DEPARTMENT OF THE ARMY
NEW ORLEANS DISTRICT, CORPS OF ENGINEERS
P.O. BOX 80267
NEW ORLEANS, LOUISIANA 70160-0267

January 4, 1988

Reference is made to your letter dated November 2, 1987 to Mr. Ed Bailey, Chief Engineer of the Orleans Levee District, and to your letter dated November 12, 1987 to this office, in which you requested our review of the in-progress plans and specifications for the 17th Street Canal, Parallel Flood Protection, Phase 1B, Hammond Highway to Southern Railway, OLB project number 2043-2047.

ENCL. 1

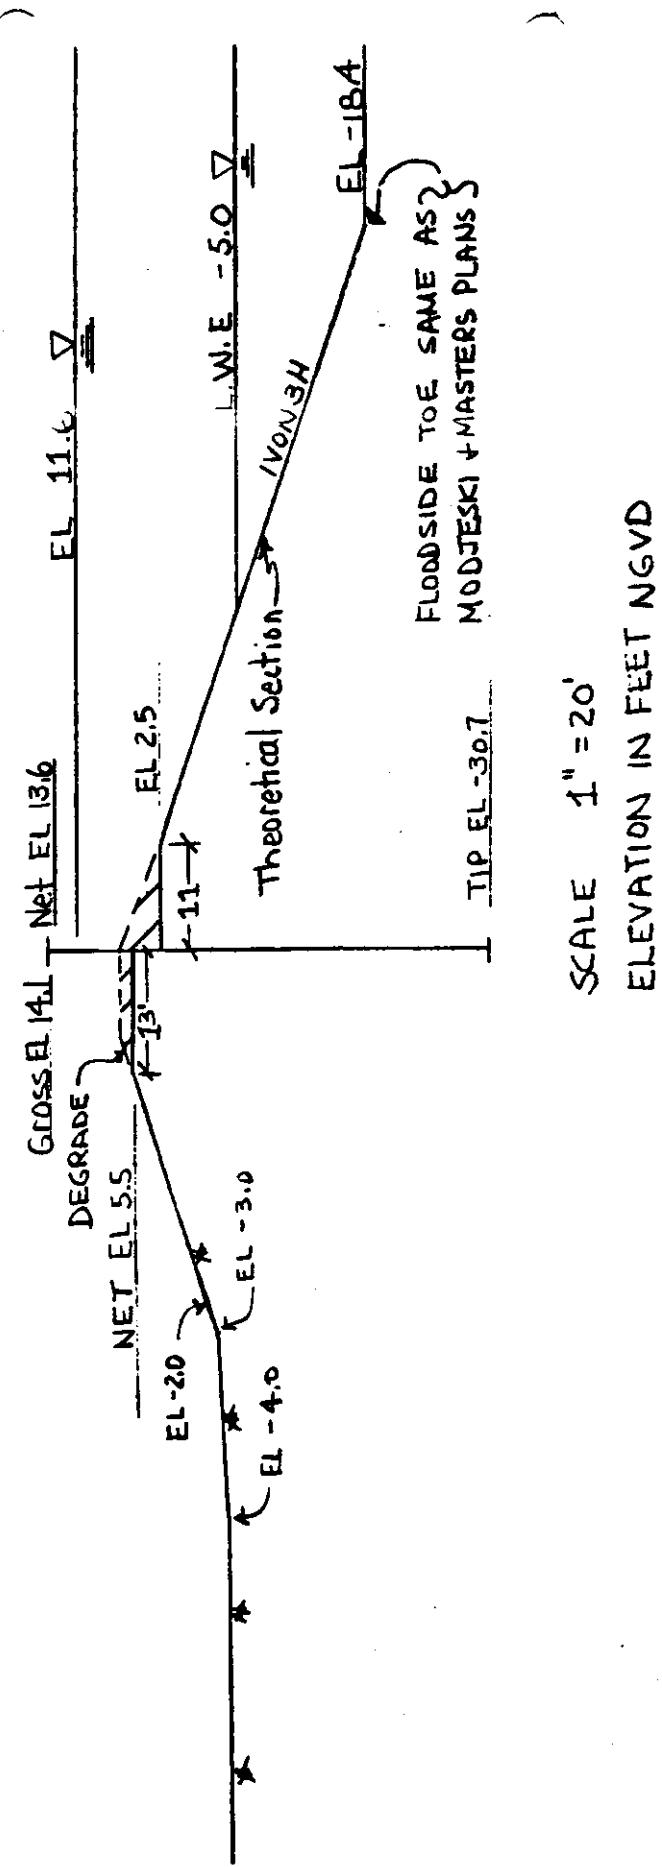
e. Our stability analysis of the floodwall reaches described in enclosures 1 through 8, indicates that a more economical design for the floodwall in those reaches can be obtained by using the floodwall layout depicted on the enclosures. It is recommended that you revise the subject plans to reflect the floodwall layout shown on the enclosures.

STA. 568+00 CANAL-SIDE FAILURE

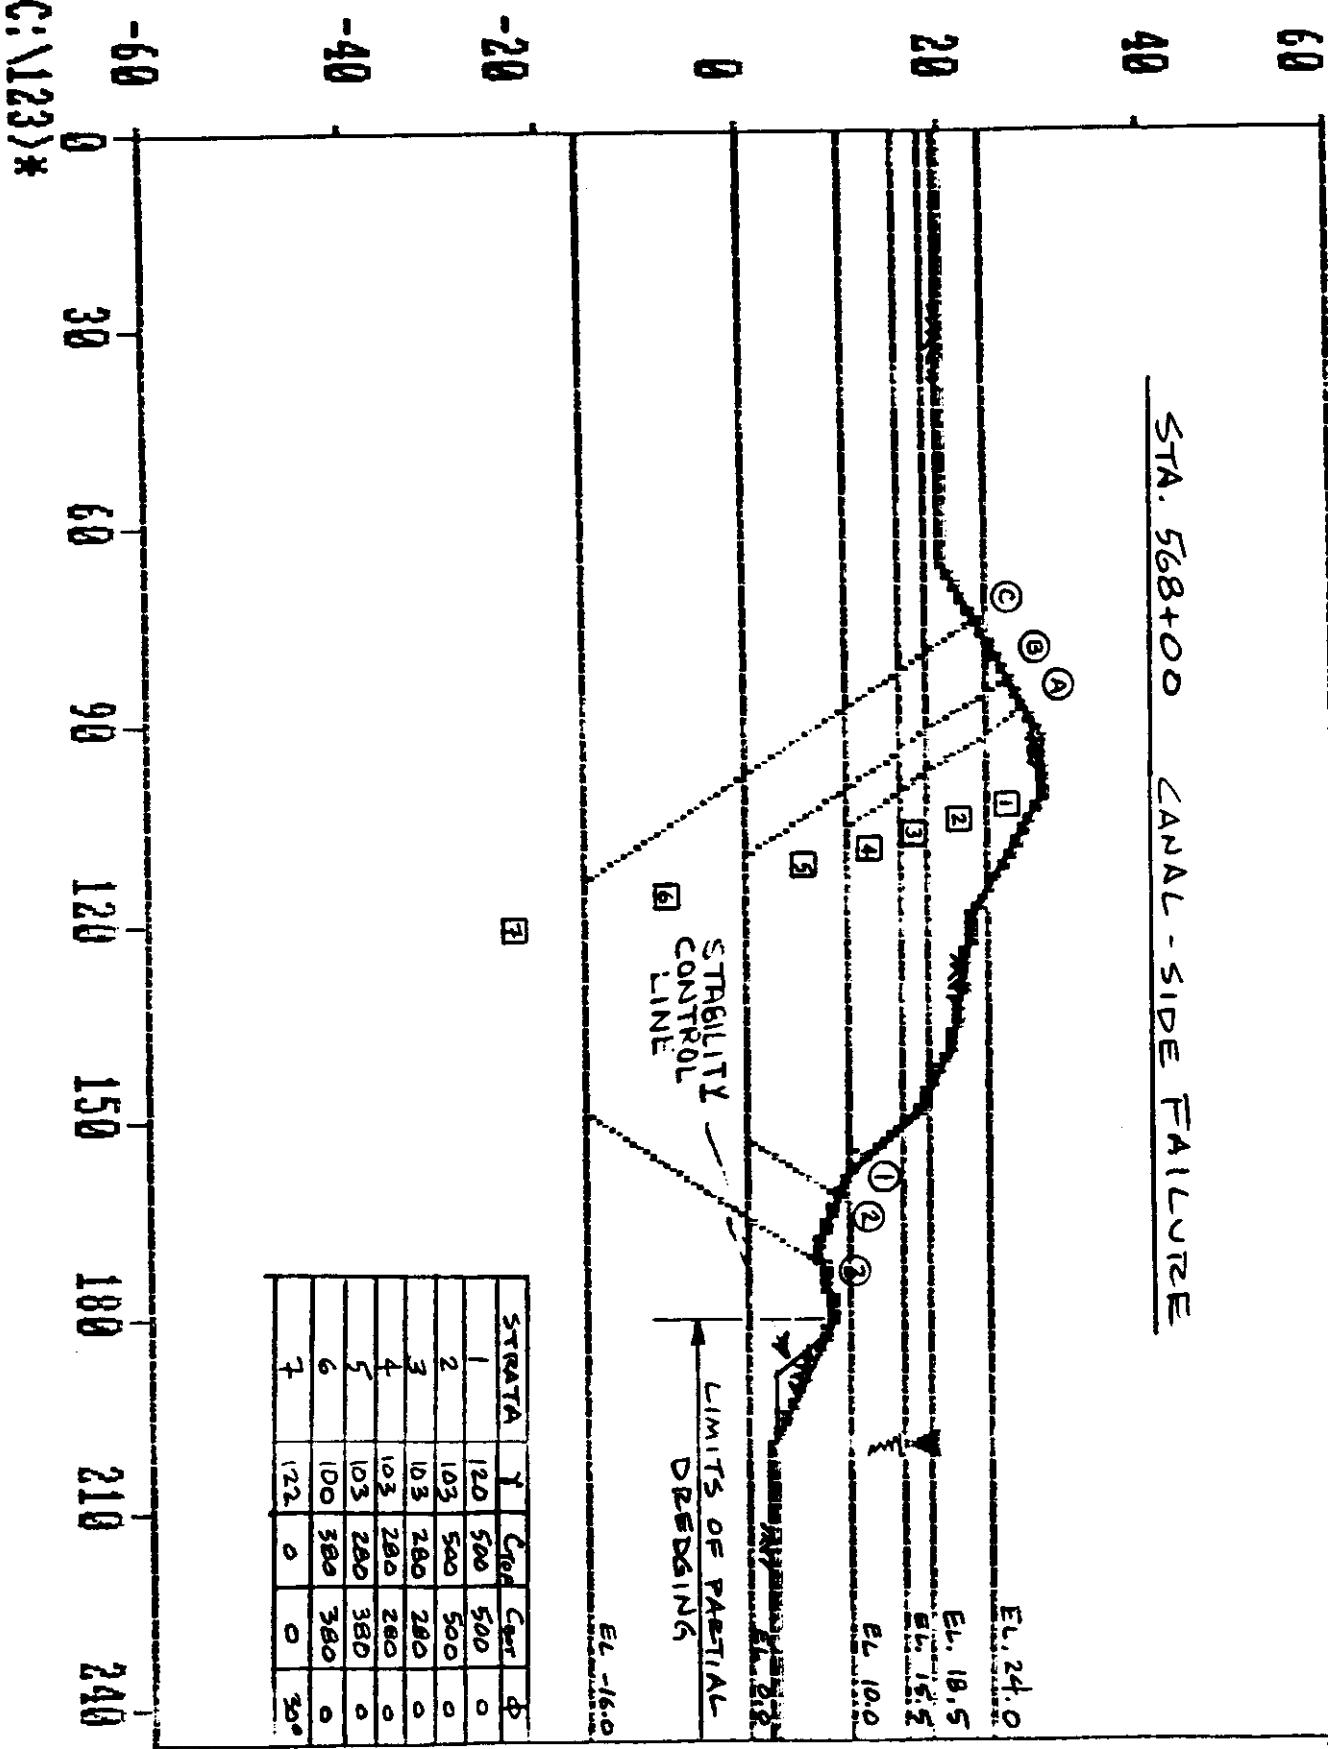
f. Since the dredging of the canal will not extend into the Jefferson Parish side, the potential for scour of the levee on this bank of the canal will exist. To be able to detect such scour, control lines, as shown on enclosures 9 through 13 will be required. These control lines should be added to the drawings. Additionally, survey cross-sections of the existing levee and canal bank, with initial cross-sections of the levee and dredged canal immediately after construction and cross-sectional surveys taken on a yearly basis thereafter, must be provided to this office. These surveys are required to detect erosion into the control lines, which if it occurs, could cause failure of the subject levee. Should erosion beyond the control lines occur, the Sewerage and Water Board of New Orleans will be responsible for taking corrective action at their own cost.
